STATE OF NORTH CAROLINA
DEPARTMENT OF TRANSPORTATION

Subject: Application for Section 404 Nationwide 14, Section 401 Water Quality Certification, and Tar-Pamlico Riparian Buffer Authorization for the construction of US 301 Bypass Improvements between NC 43/48 (Benvenue Road) to SR 1836 (May Drive) in Nash County. TIP No. U-3330. Debit \$570 from WBS 36596.1.2.

The North Carolina Department of Transportation (NCDOT) proposes to widen the US 301 Bypass in Rocky Mount from Benvenue Road to May Drive in Nash County, NC.

PROJECT REFERENCE NO. U-3330	SHEET NO. 10
R/W SHEET NO. ROADWAY DESIGN ENGINEER	HYDRAULICS ENGINEER
INCOMPLETE PLANS DO NOT USE FOR A/W ACQUISITION PRELIMINARY PLANS DO NOT USE FOR CONSTRUCTION	
PERMIT DRAWING SHEET 23 OF 28

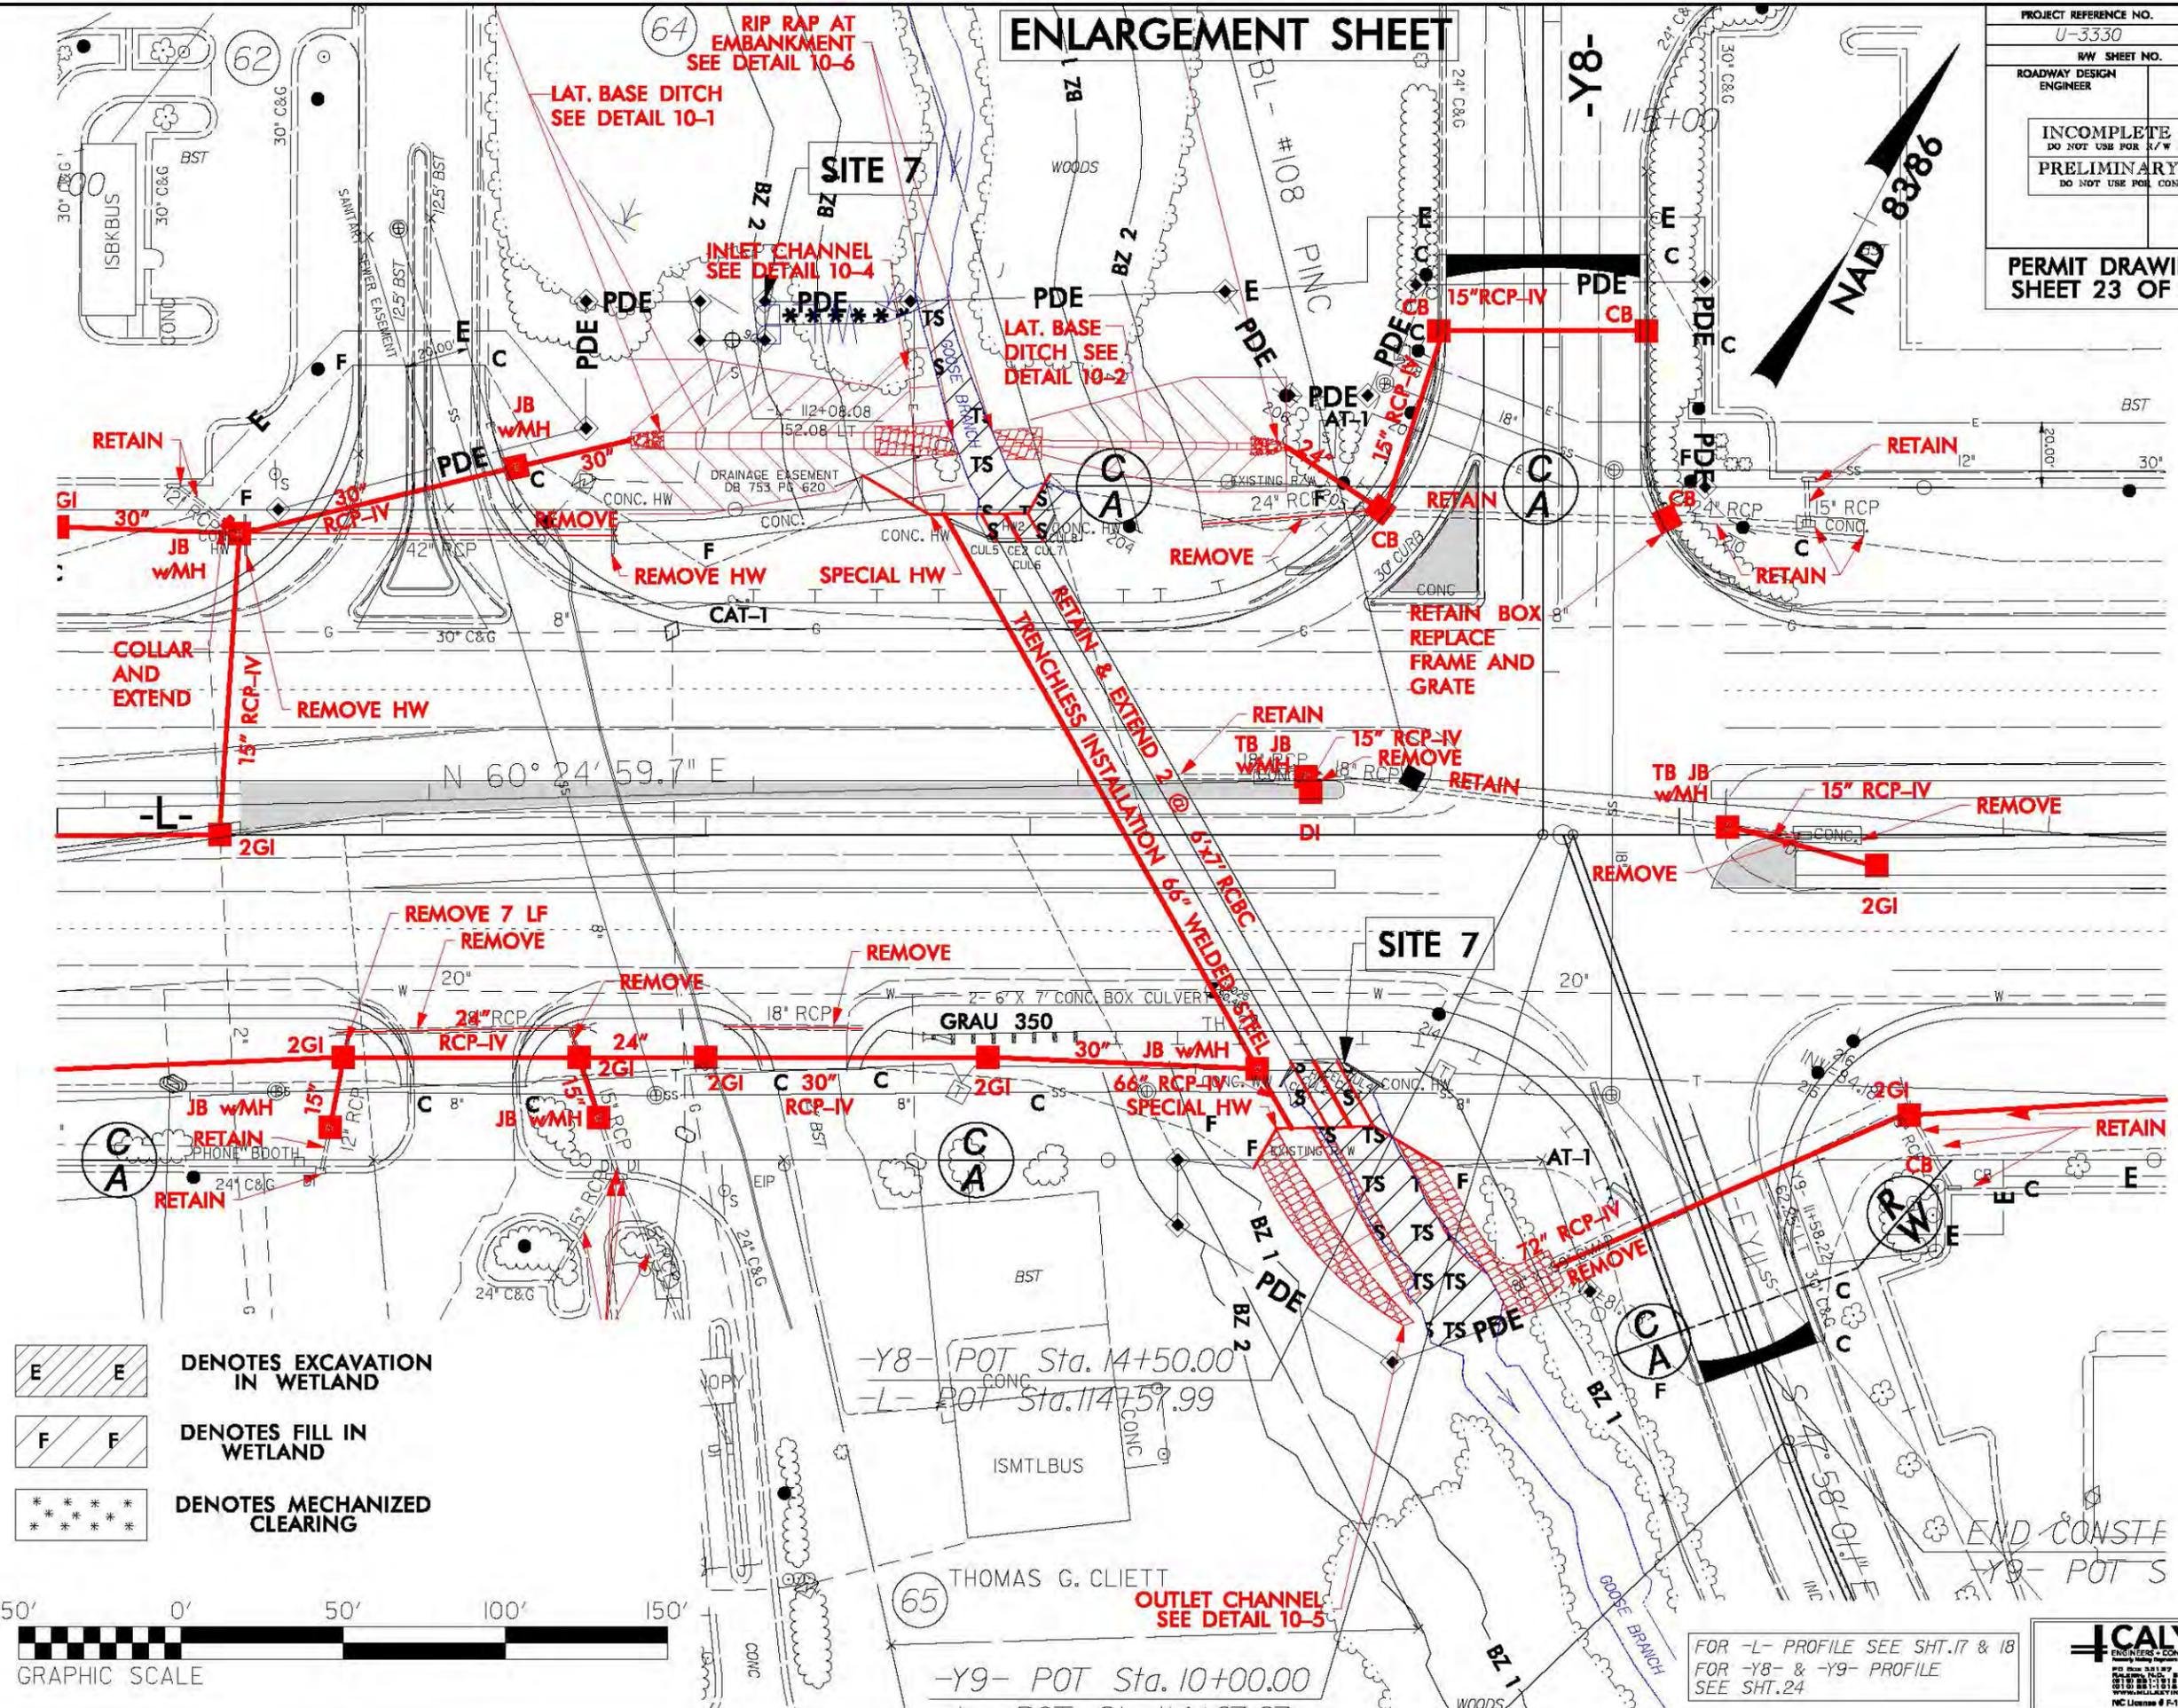
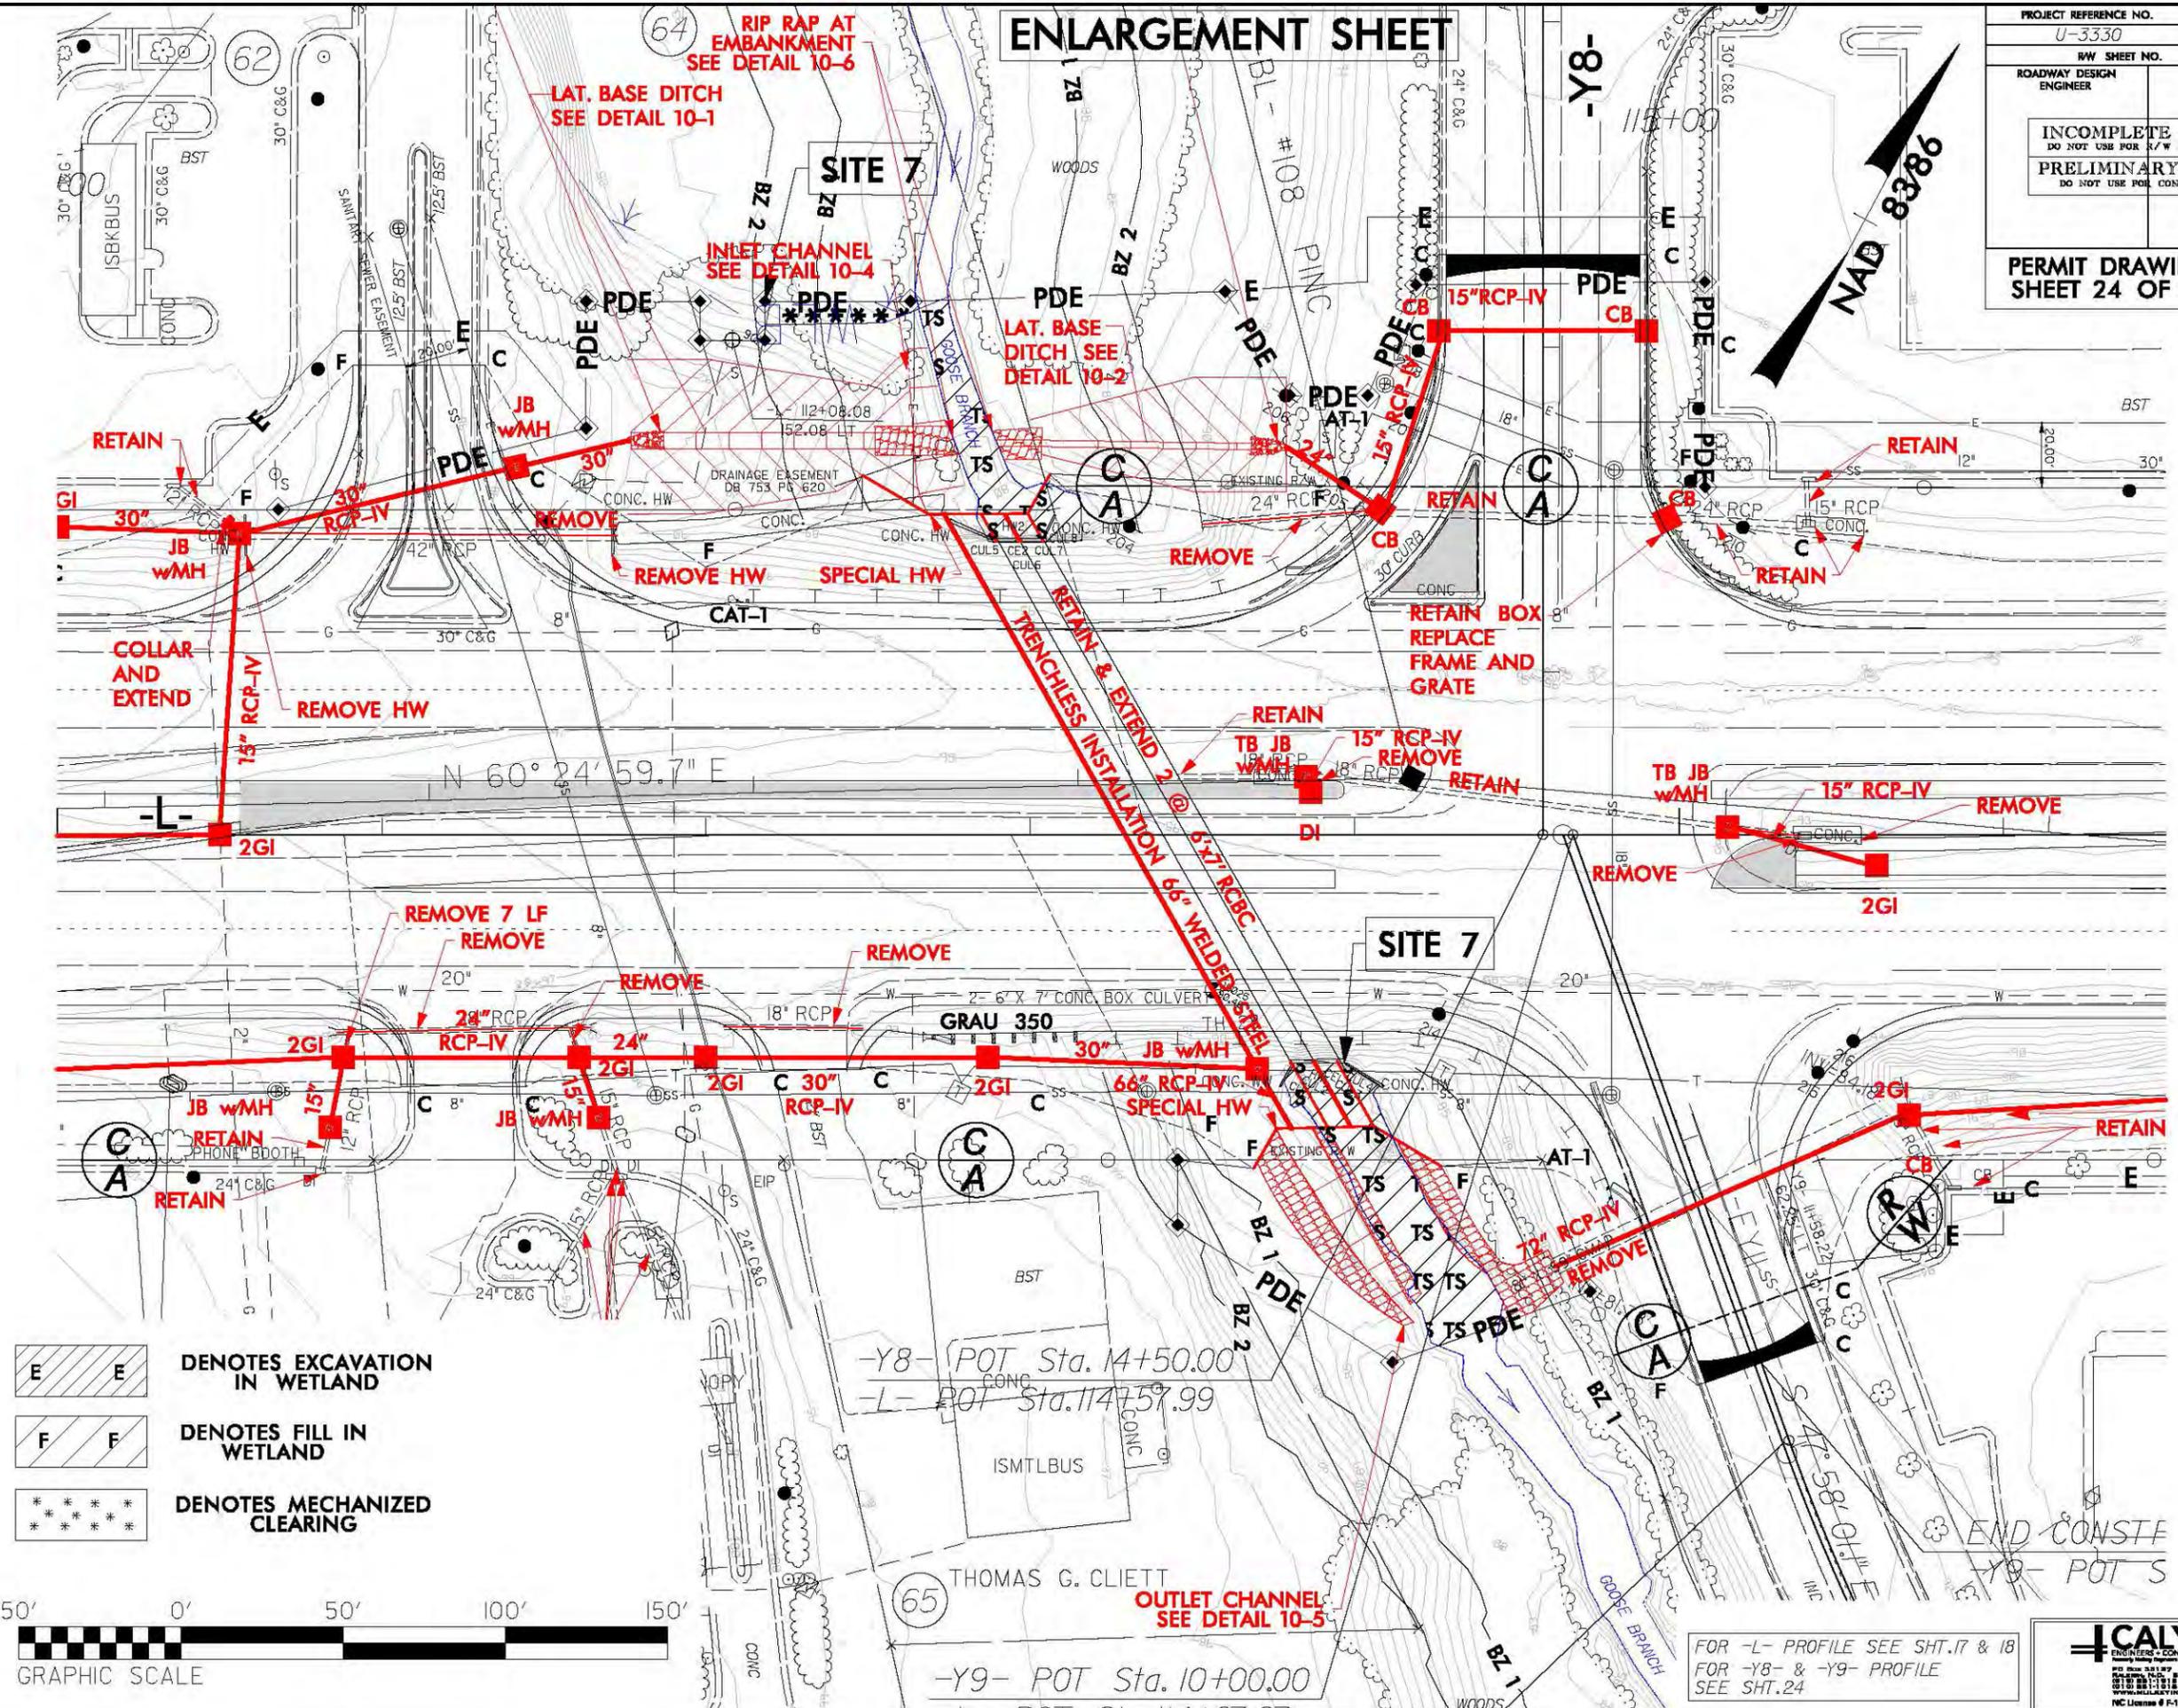
Site 4 - Plan Sheet 10 – Goose Branch - Box Culvert and cross pipe on Y line

- Consider adding riprap at the outlet of the 72” RCP-IV under –Y9- since it is outside of the Jurisdiction Stream. Also, consider adding bank stabilization in this area.
- The Division requested that hand clearing be replaced with mechanized clearing (10’) or to the temporary construction easement.
- Correct level symbology for 66” RCP overflow pipe at outlet.
